MANDATORY SERVICE BULLETIN

NO. MSBD4-026/1

WORK INSTRUCTION WI-MSBD4-026/2

„INSTALLATION OF THE TAE 125 R5 ENGINE“

**Figure 2a: TAE 125 Diesel Engine Components,
 Engine S/N 02-01-0309-SL01-004-0101 and higher**

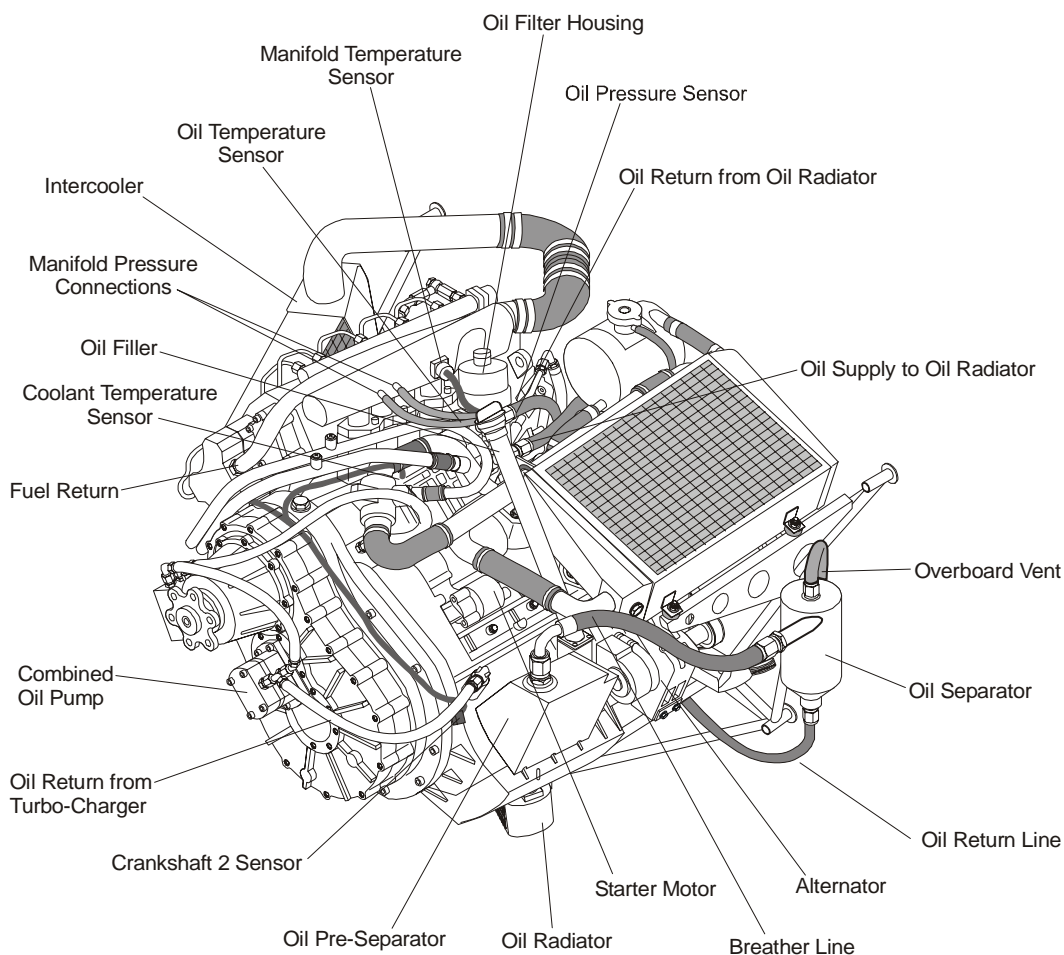
Note: If you remove an engine with a serial number which is not higher than 02-01-0309-SL01-004-0100, and replace it with an engine with serial number 02-01-0309-SL01-004-0101 or higher, then you must carry out Service Bulletin No. OSBD4-026 before you install the new engine.

Figure 1: Intercooler Installation

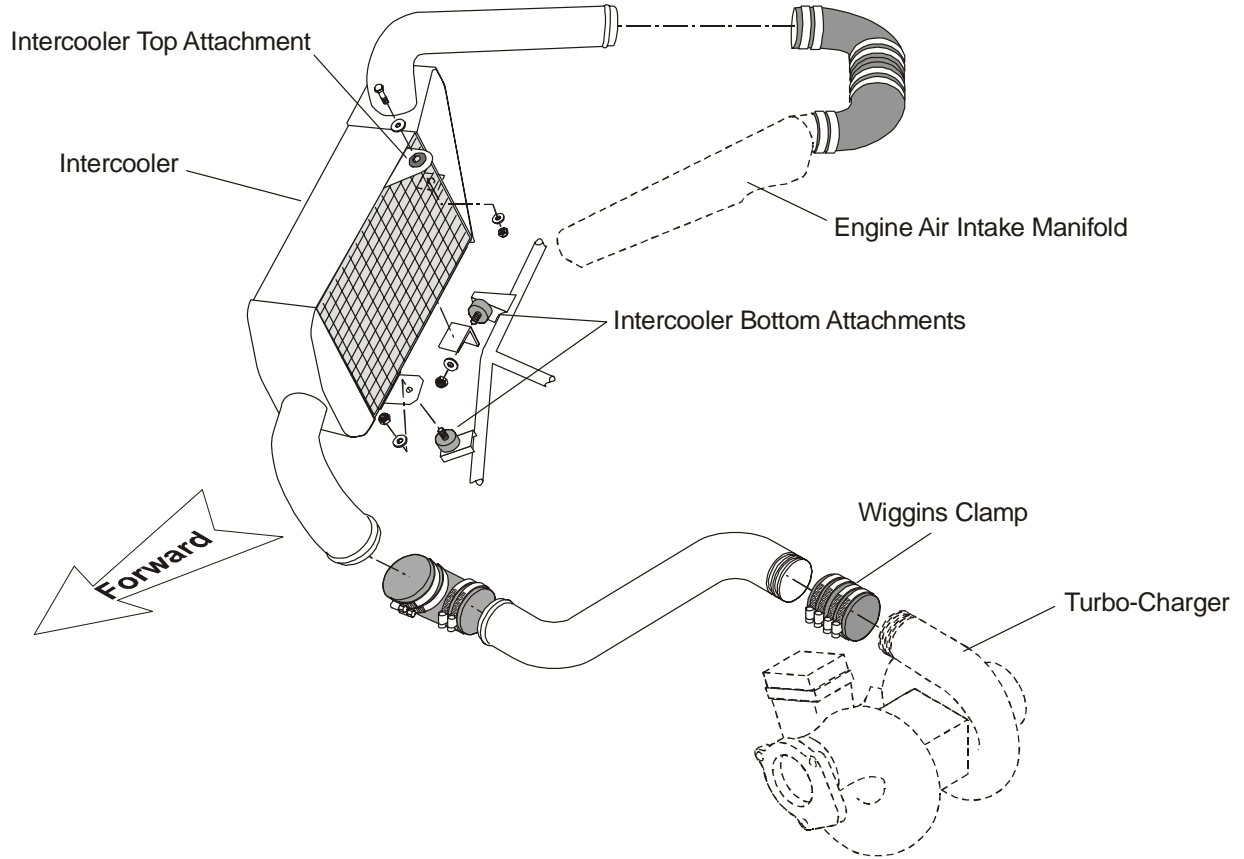
The outlet from the intercooler connects to the engine inlet manifold. ~~A manifold pressure sensor and a manifold temperature sensor attach to the outlet pipe from the intercooler.~~

(2)	Put the intercooler in position on the engine mount. <ul style="list-style-type: none"> - Move the inlet and outlet pipes into position in the related flexible hoses. 	Refer to Figure 1.

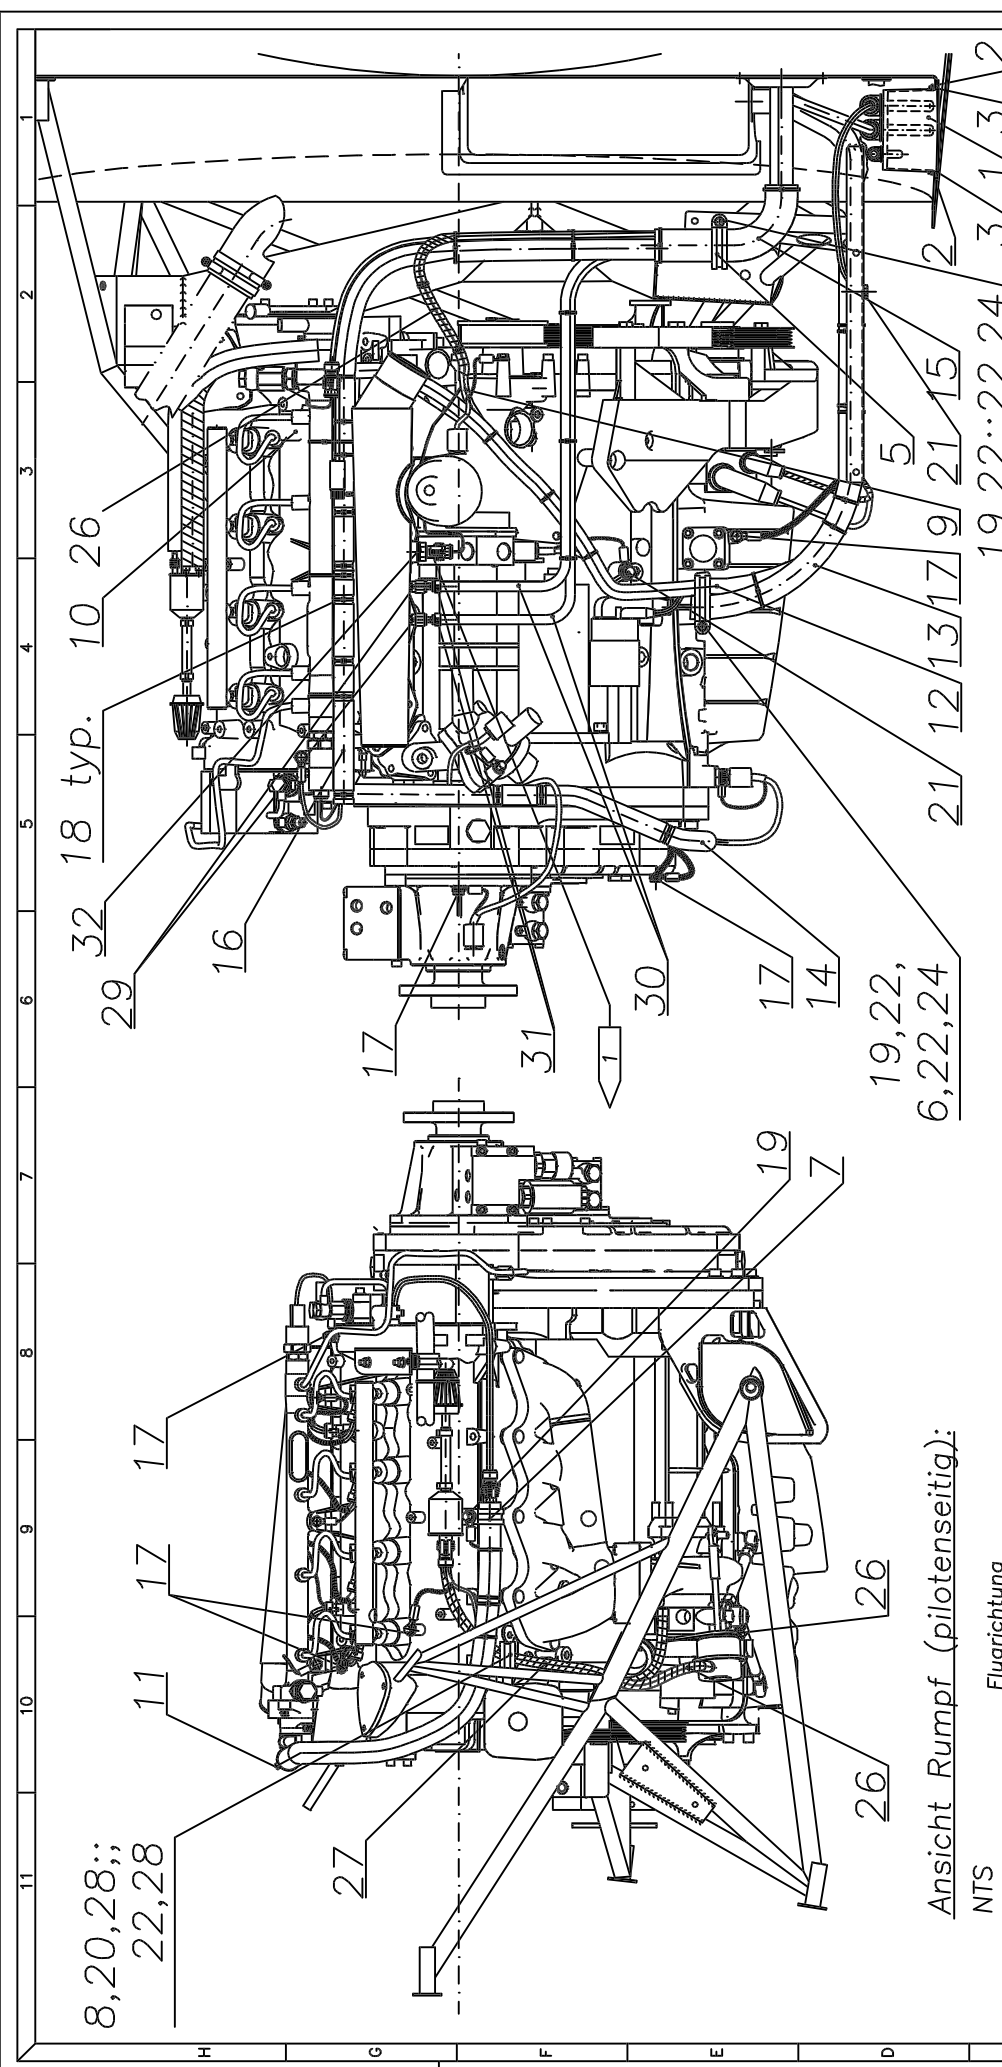
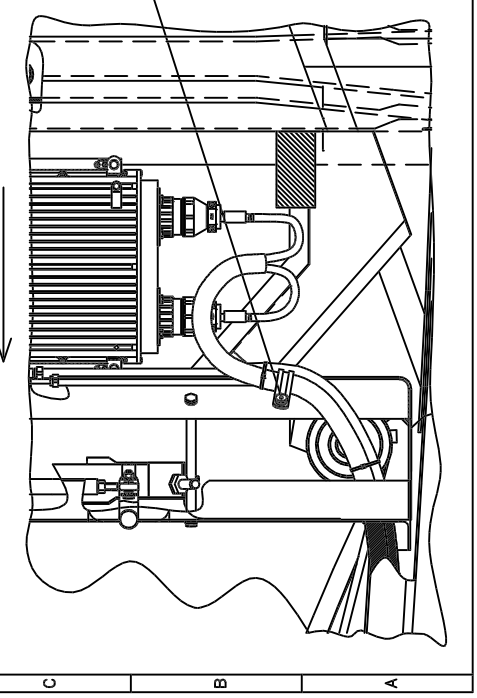
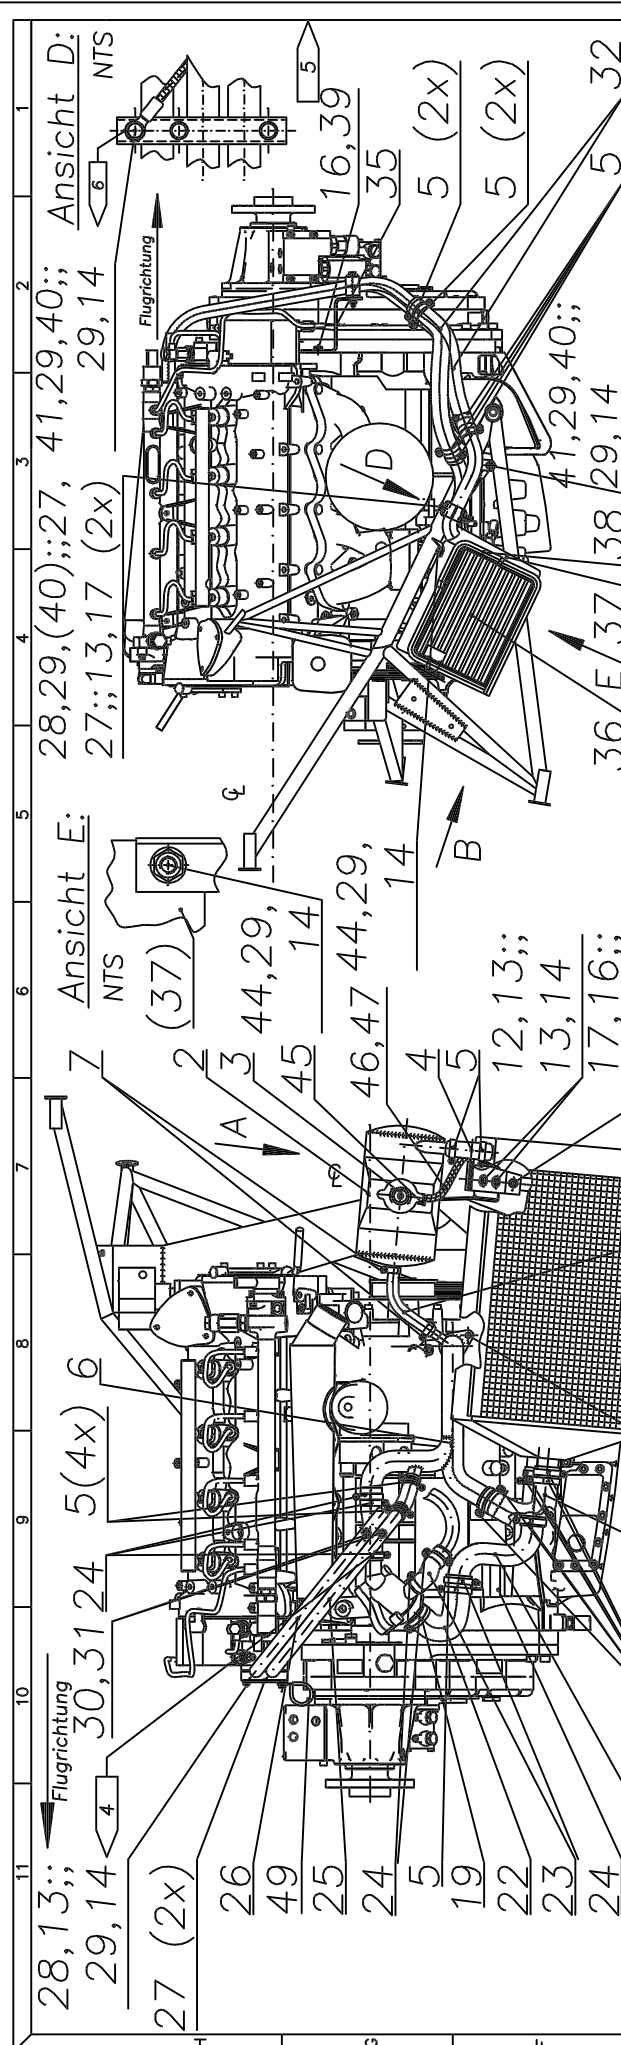
7	Install the Manifold Pressure connectors part no. D4D-7156-11-00 in accordance with dwg. no. D4D-7156-01-00, items 29, and the second Manifold Pressure line (A) with tube part no. 3225-10052 in accordance with dwg. no. D4D-7156-01-00, items 30 using hose clamps 8-12 mm, part no. 11.0630.
8	Connect the air temperature sensor, item 32 on dwg. no D4D-7156-01-00.
9	Install the mountings for the Intercooler from part nos. LN9037 M6x16, DS-BW1-B14-RB6-RB6-040, LN9037 M6x18, DIN 125-A2-M6, DIN985-A4-M6 and Z6313617 in accordance with dwg. no. D4D-8126-01-00, views F and G, items 17, 19, 20, 24, 27, 28.
10	Install the new Intercooler (part no. D4D-8126-20-00) and the new connecting pipe (part no. D4D-8126-30-00) in accordance with the Airplane Maintenance Manual Doc. No. 6.02.01 and dwg. no. D4D-8126-01-00 with new O-rings for the Wiggins clamp part no. 60.0660.
11	Install the vibration mount part no. 316-041 in accordance with dwg. no. D4D-7526-00-00, item 49.

Zeichnung Nr.: D4D-7526-00-00
 Blatt 1
 D4D-7526-00-00.dwg
 Erw. Nr.:

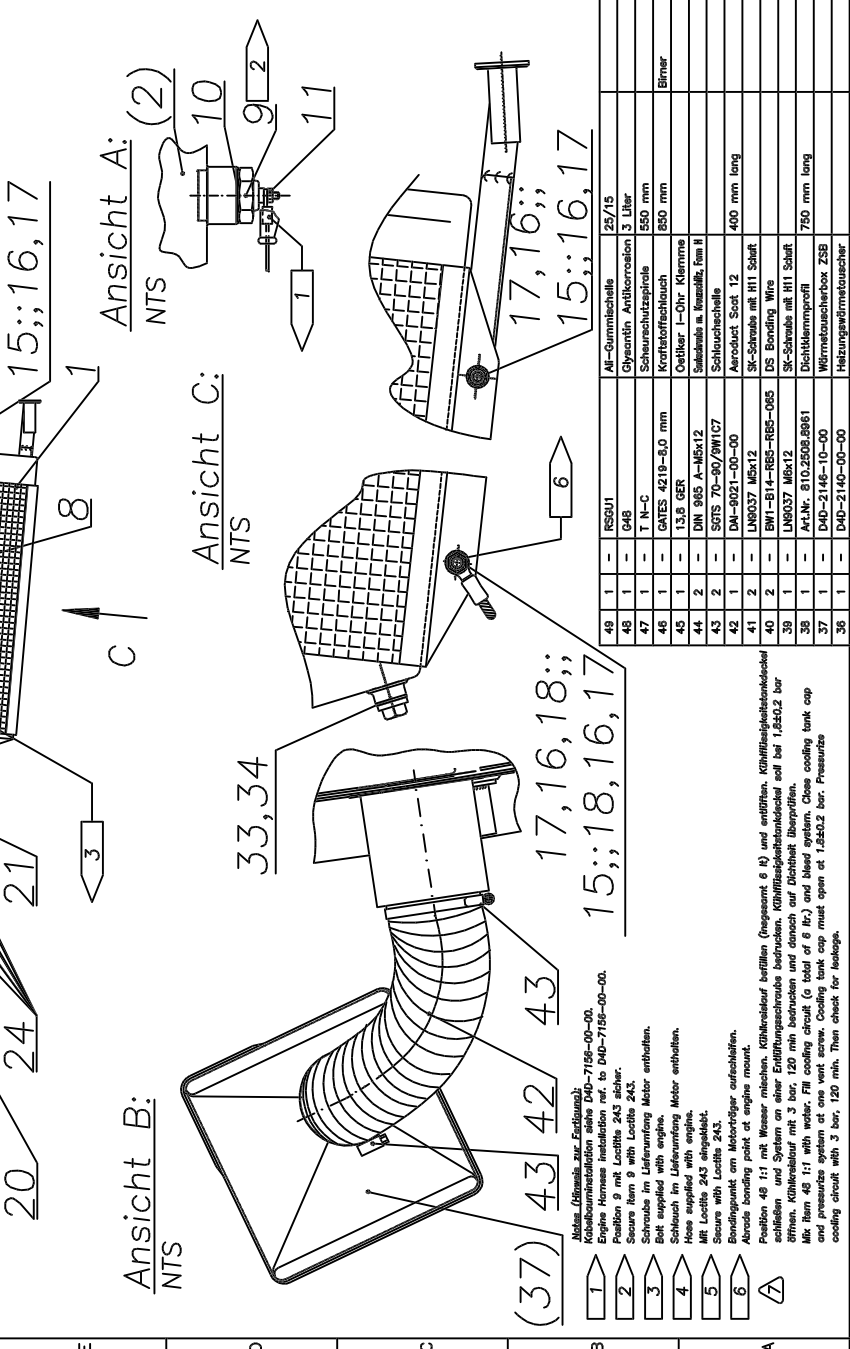
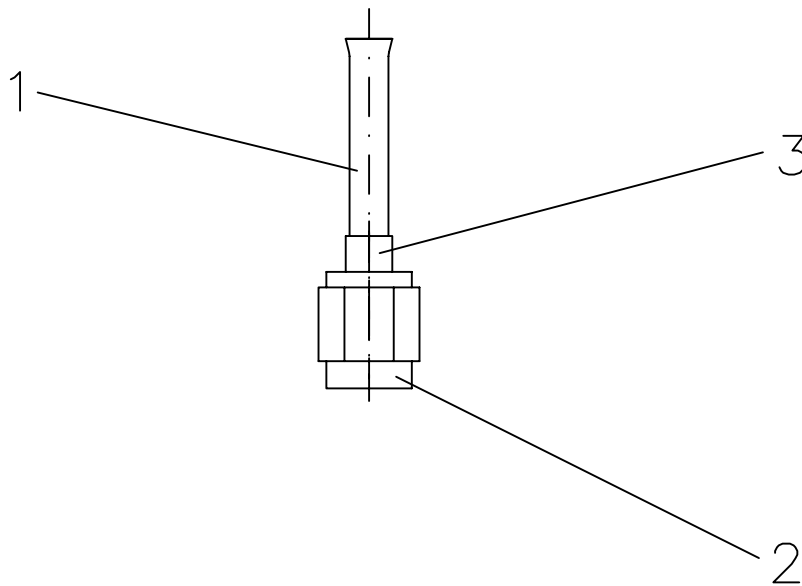
1	Remove top and bottom cowling in accordance with the Airplane Maintenance Manual, Doc. No. 6.02.01.
2	Remove the engine and the ECU in accordance with the Airplane Maintenance Manual, Doc. No. 6.02.01 and disconnect the AED and the CED.
3	Install the new ECU in accordance with the Airplane Maintenance Manual Doc. No. 6.02.01. Remove the mounting brackets from the old ECU and install them on the new one.
4	<p>Install the ECU connectors in accordance with dwg. no. D4D-7153-01-00 with Oetiker clamps (items 27) part no. 11.1544.</p> <p>NOTE: The old ECU connection consisted of only one tube each for Static and Manifold Pressure running forward. The new ECU connection consists of two tubes for the Manifold Pressure, as seen on dwg. no. D4D-7153-01-00.</p>
5	Install the new Manifold Pressure line part no. D4D-7153-14-00 to the ECU in accordance with dwg. no. D4D-7153-01-00.
6	<p>Install the new R5 engine part no. 60.1300 in accordance with the Airplane Maintenance Manual Doc. No. 6.02.01.</p> <p>NOTE: As shown on dwg. no. D4D-7526-00-00, the connectors (items 32) to the heat exchanger have been swapped.</p>
